**ADDENDUM NO. 3**

FOR: WEBB COUNTY YOUTH VILLAGE REHABILITATION CENTER  
FOR WEBB COUNTY  
111 CAMINO NUEVO ROAD, HWY 359  
LAREDO, TEXAS 78041

ADDENDUM DATE: July 6, 2016

ARCHITECTS PROJ. NO.: 1401

PROJECT NUMBER 14.4.07
REVISIONS ▲ ADDENDUM #3 7/05/16
FILENAME:
SHEET TITLE ELECTRICAL RISER/SCHEDULES
DRAWN BY:
SHEET NO. <b>AE5.1</b>
DATE: JUNE 29, 2016

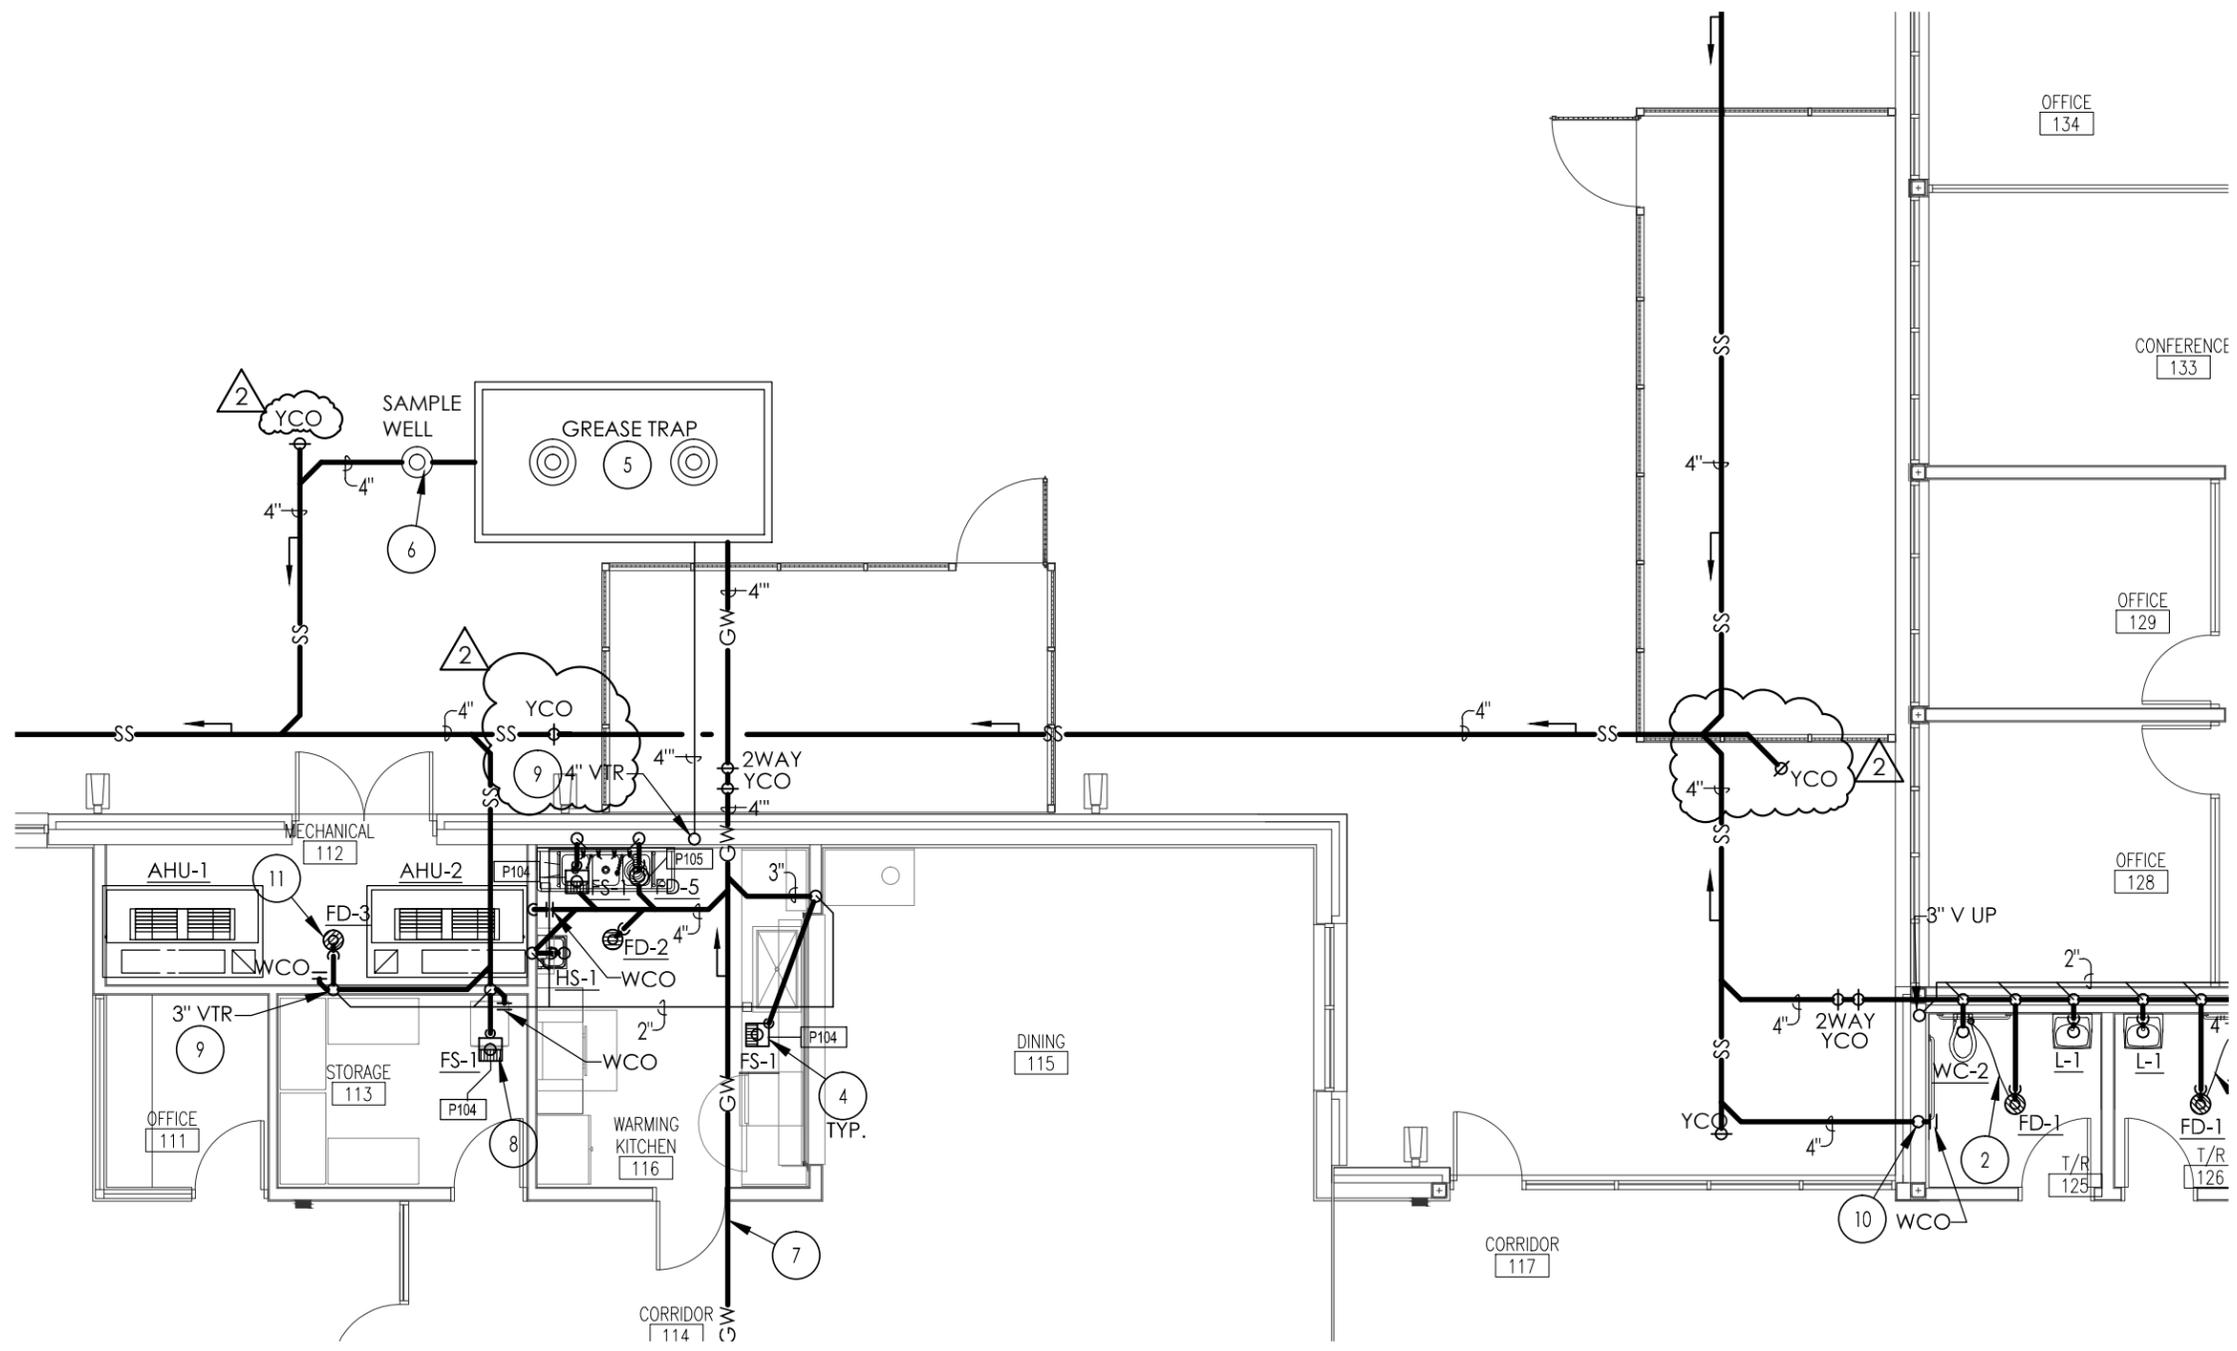
D3-12	E5.1	<ol style="list-style-type: none"><li>1. Revise as shown in attached sheets AE5.1</li><li>2. Add Electrical Riser Diagram Keyed Notes, item 12; refer to attached sheet AE5.1</li></ol>
D3-13	E5.2	<ol style="list-style-type: none"><li>1. Revise Electrical Panel Schedules; refer to attached AE5.2</li></ol>
D3-14	P1.1	<ol style="list-style-type: none"><li>1. Revise Electrical Panel Schedules; refer to attached AP1.1-A</li></ol>
